Authors' reply to editor's and referees' comments

MS No. nhess-2020-79

Editor Decision: Reconsider after major revisions (further review by editor and referees) (05 Sep 2020)
by Paolo Tarolli

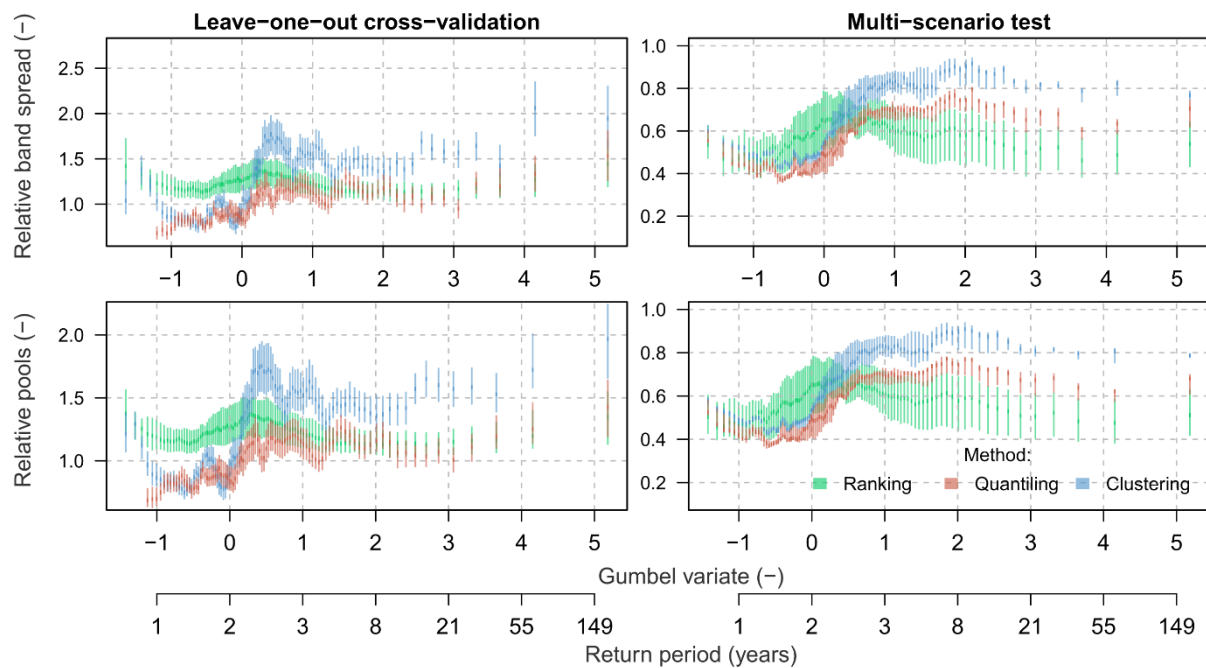
Line 330: Here we propose to use different percentiles, i.e., the 5th, 50th, and 95th percentiles, to characterize the ratio of the simulation points lying outside the computed predictive intervals for each of the methods. I don’t understand this? Why not using only the 50th percentiles of this ratio? Refer to comments on Table 3 for a more detailed version of this question.

AR: We thank the reviewer for this very useful comment! In the revised manuscript, we included two additional metrics that should put more focus on extreme floods. The newly proposed metrics are the relative band spread of predictive intervals ($R_{\Delta PIs}$) and the overlapping pools of the predictive intervals (R_{OPPIS}). The latter metric is an adaption of the suggested by the reviewer computation of pools lying outside PIs. These new metrics are described in text in sect. 2.6.2, i.e. Quantitative assessment (lines 348-360 & 371-373):

“Analysis of overlapping PIs pools (R_{OPPIs}) and relative band spreads ($R_{\Delta PIs}$) show that in the cross-validation test, all methods provide bands that are wider than the 90%-PIs computed using the full simulation ensemble. This should not surprise as the selection of relative parameter sets is based on a large sample of hydrologic model realisations (i.e. 99 scenarios) than the full ensemble for model assessment (i.e. single scenario). However, these metrics show large differences in the multi-scenario test, in which the clustering method outperforms other two selection methods, particularly when the focus lies on rare floods (compare $R_{\Delta PIs,j \geq 51}$, $R_{\Delta PIs,j \geq 91}$ and $R_{\Delta PIs,j \geq 96}$ in Table 3). The quantiling was the second good method, while the ranking was performing the worst. These observations are also confirmed when looking at the variability of these two metrics for different return periods (Fig.10). A better performance of the clustering method can be again noticed in the range of rare floods. While quantiling was performing worse than clustering, it was still better than the ranking method.”

In addition, we introduced an additional figure which presents cumulative results of these two metrics for all scenarios (new Figure 10).

Figure A2. Flow duration curves and model performance metrics for calibration and validation periods over all 100 optimized parameter sets.

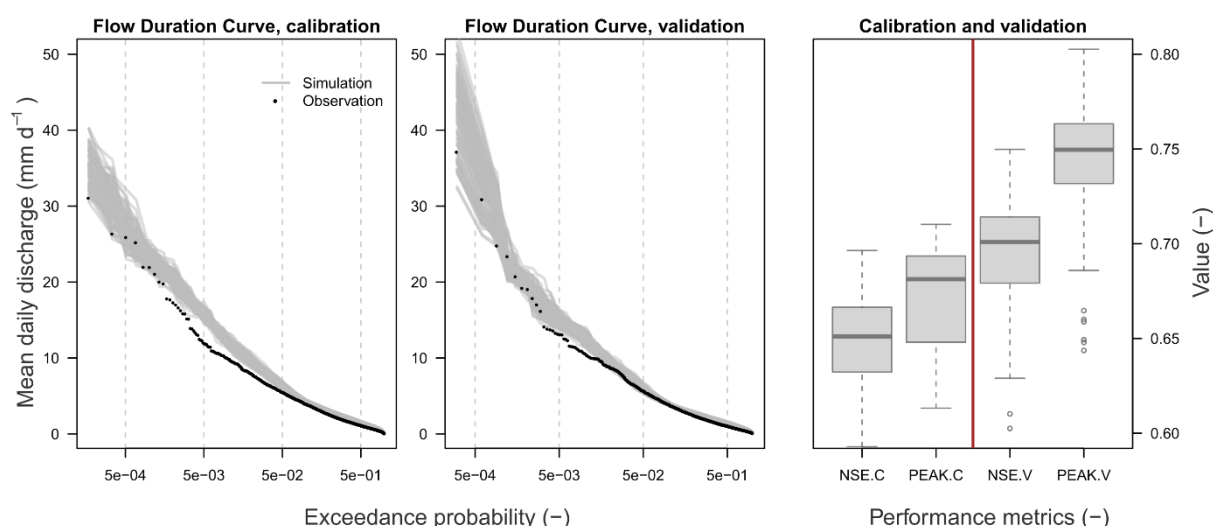
Line 381: *The median model efficiency measured with F_{obj} over all 100 runs is 0.7.* To better assess the quality and the variability of the models generated at this step, it would be useful to show the distribution of NSE (Nash & Sutcliffe Efficiency) for both calibration & validation, and the ensemble plots of daily regime and classified discharge distribution for all the generated models. The ensemble simulation of the biggest observed would also be very pedagogic.

AR: *The Nash-Sutcliffe values for the calibration and validation periods are now provided in the revised manuscript in newly included Appendix: Model calibration results. In addition, flow duration curves are provided for mean daily discharges for simulated versus observed values and these are also included in the same appendix.*

Figure A3. Variability of 100 meteorological scenarios used in this study vs. observations.

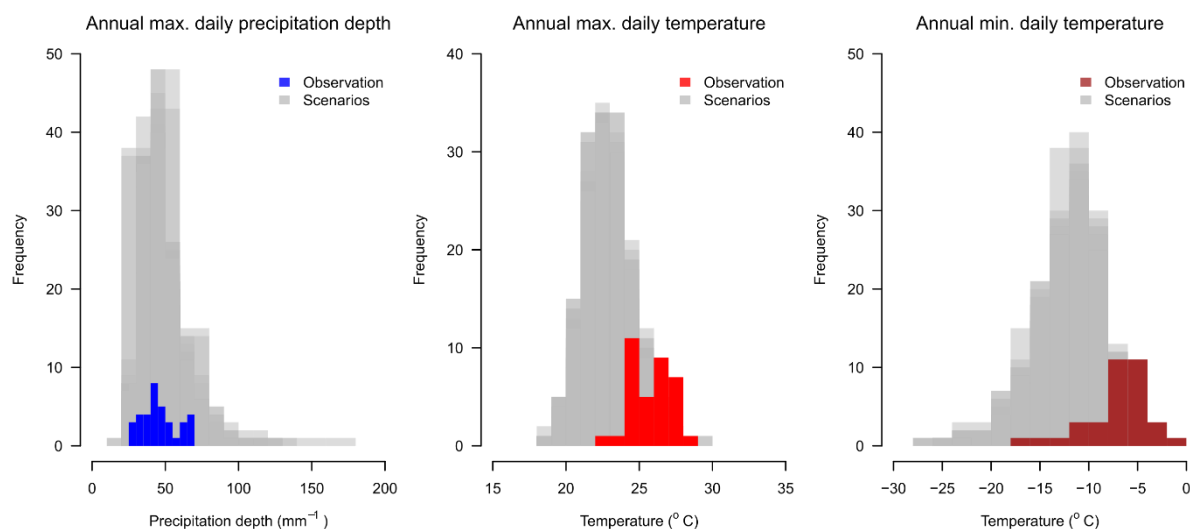
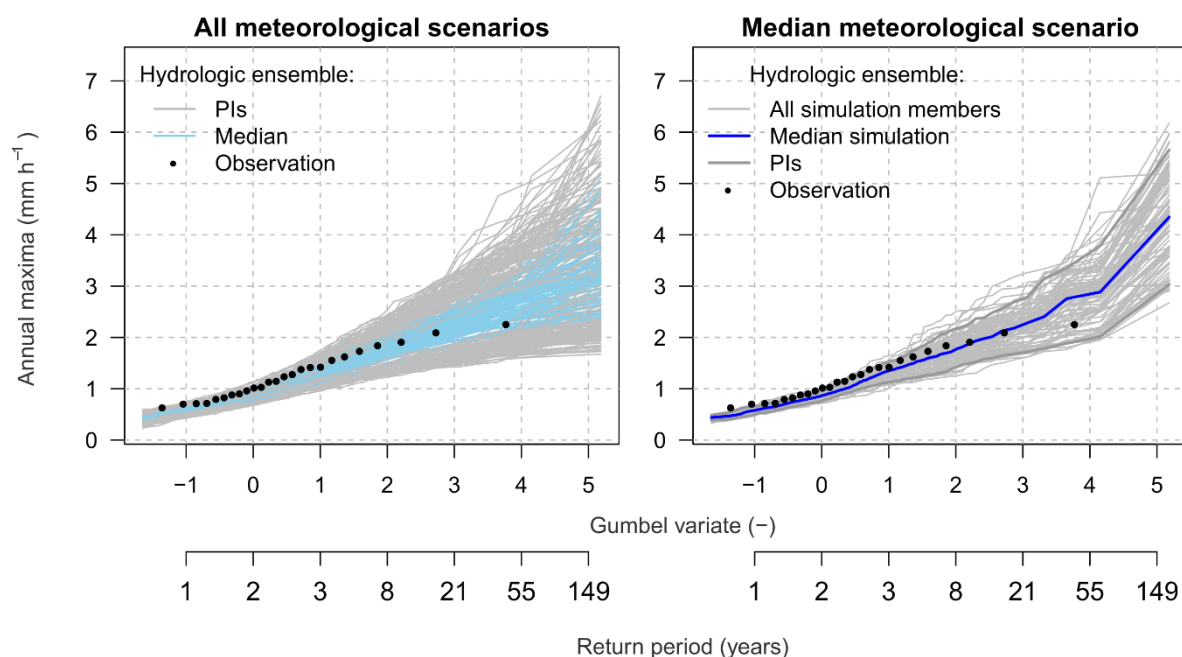
Line 403: *Thus, differences between scenarios are exclusively due to the natural variability of the meteorological time series. “[: : :] and modelled by the GWEX weather generator” could be added.* Similarly to the models, the variability of these scenarios deserve to be illustrated, and compared to the observations, e.g. thanks to their average and standard deviation of the annual maximum daily precipitations.

In addition, the variability of meteorological and resulting hydrologic scenarios is presented in a newly introduced figure in the new Appendix: Scenarios variability and briefly described in the appendix.

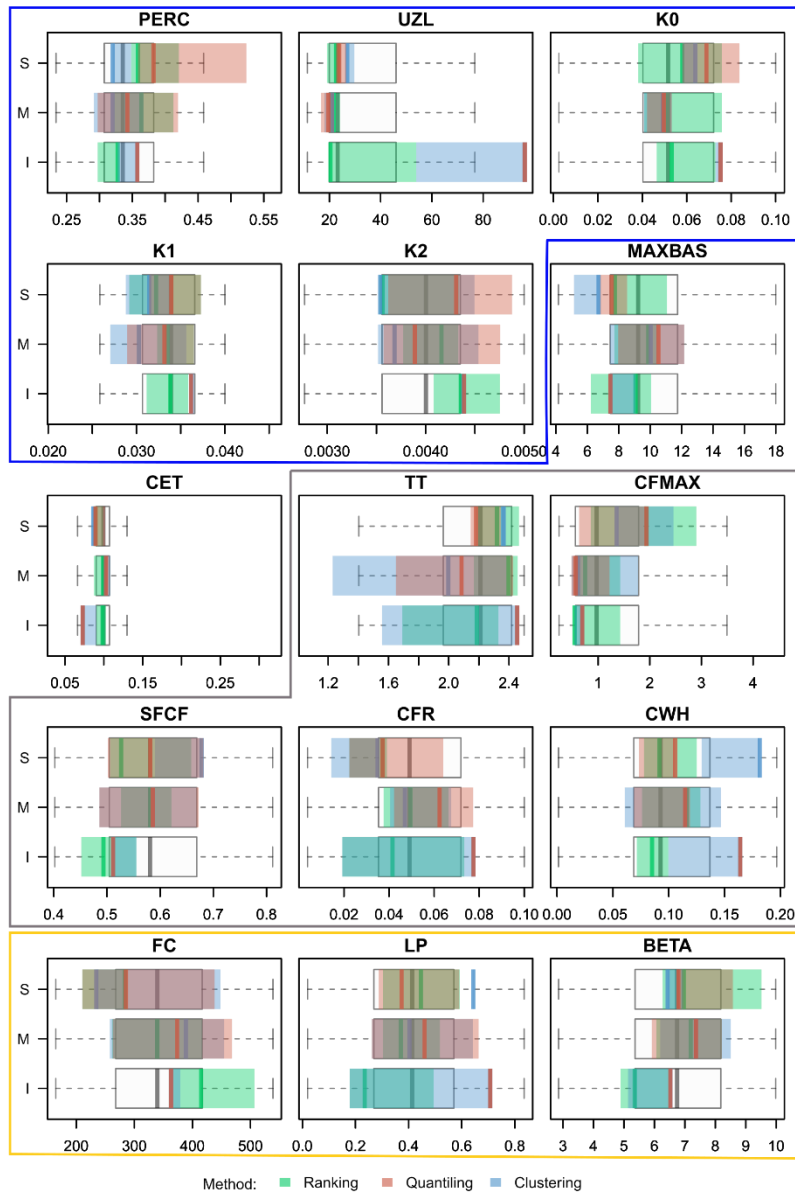
Lines 419-434: I find the results of this paragraph difficult to interpret. Some violin plots show odd parameter selection patterns (like in Clustering/Infimum), other show weak parameter discrimination (Quantiling/Median). The Table 2 is quite difficult to read/interpret with so many counts exposed. In this paragraph and in the following ones, some “illustrations” of the most selected parameter sets should be provided, e.g. by presenting the range of hydrological responses to observed meteorological data of the selected models compared to the full ensemble. In other words, some interpretation in term of modelling and hydrological processes would be welcomed.

AR: we remove the violin plots, and instead, we included an alternative figure that presents a grouping of representative parameters selected with three methods. This enables us to look at how the selection of parameters corresponds to different processes being modelled by the model.

Following the new figure, a new paragraph was included in lines 475-483:

“The variability of selected parameter sets is presented in Fig.5. As can be seen from the figure, some parameters presented smaller and others larger variability of selected sets. It also appears that different values are selected for the infimum, median and supremum set but not always. Among three selection methods, the ranking method (marked in green) has the largest spread of parameter values for most of the parameters. The clustering (blue) and quantiling (yellow) selection methods seem to choose more extreme parameter values for both, i.e. infimum and supremum sets. Looking at different model routines and hydrological processes behind, no clear patterns could be seen regarding the choice of parameter sets. It appears however that the representative parameters from the response (blue) and soil moisture (yellow) routines have a smaller spread than those from the snow routine (grey), as they are more often outside and further away from the interquartile ranges (grey boxplots).”

Figure 9. Example of multi-scenario evaluation for the three selection methods and two meteorological scenarios. PIs represent the 90% predictive intervals

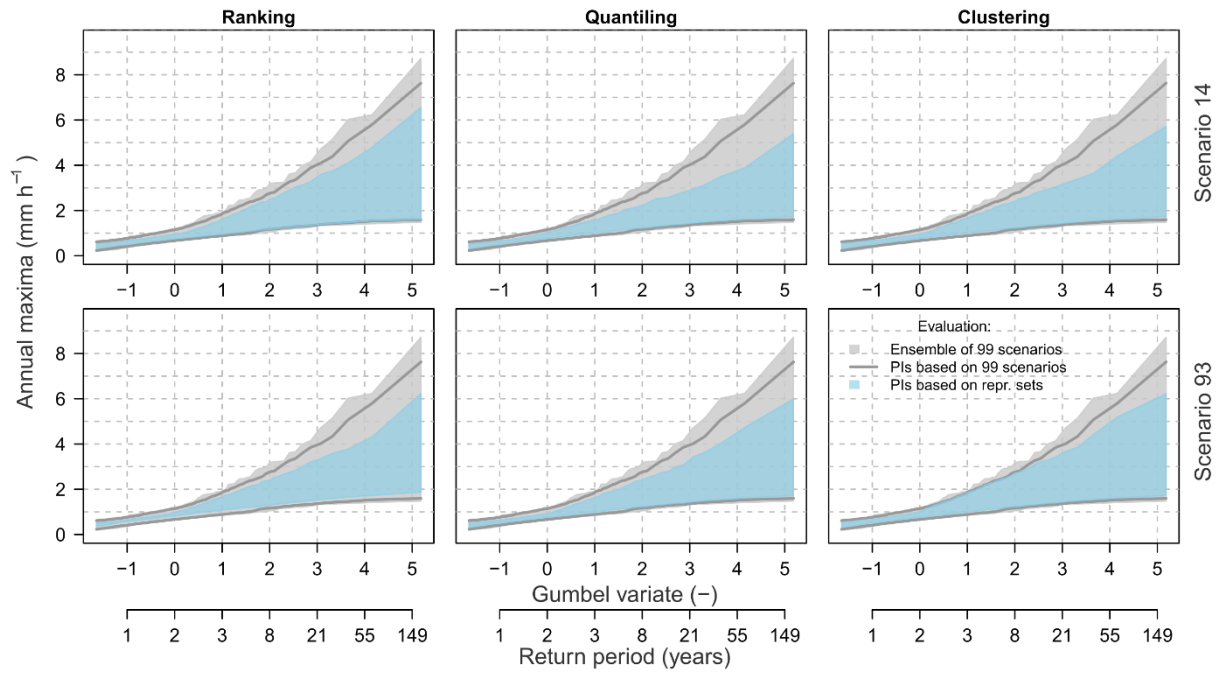
Figure 7-8: I found the plots of the top panels of both figures rather counterintuitive: *the prediction interval resulting from selecting representative parameter sets for 99 meteorological scenarios and compared to the full simulated range with all 100 parameter sets seems narrower than “statistically expected”* (more and less a 5-95% confidence interval given the quantiles or percentiles involved in the process). For the highest simulated quantiles, the prediction interval seems only to cover about 50 to 66% of their variability. In the bottom plot of the Figure 7 for clustering, a second blue interval is plotted without being identified in the legend nor in the caption.

AR: *This second blue interval is indeed the grey interval, which comes from the scenario assessed here. For clarity, we redesigned these plots by removing the upper panel, which might have been misleading, and by improving the readability of the bands.*

Figure A1. Violin plots (blue) summarizing 100 optimized parameter sets of the HBV model for the Dünneren at Olten catchment vs. initial calibration ranges (gray). Units as in Table A1.

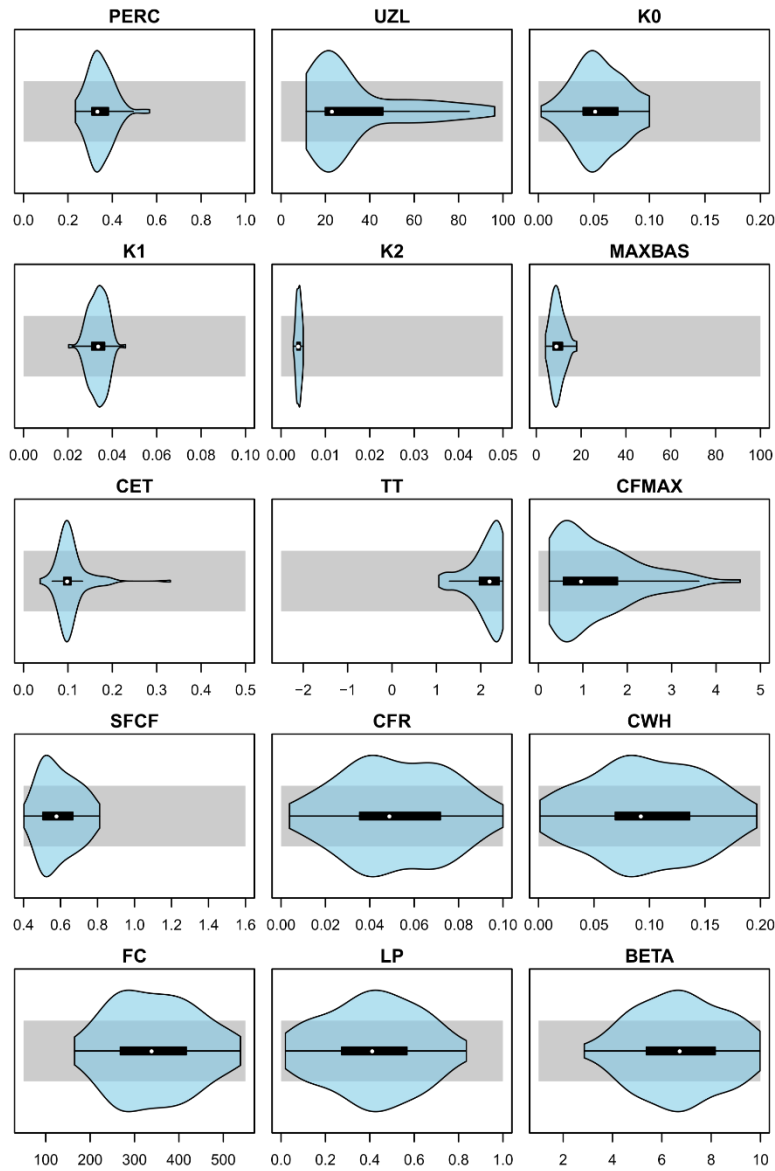
Figure A3: For a better assessment of the distribution of calibrated parameters, I suggest that the scale of the horizontal axis of the violin plots (parameter values) exactly matches the corresponding calibration range written in the Table A1.

AR: The figure was updated with initial calibration ranges as suggested.
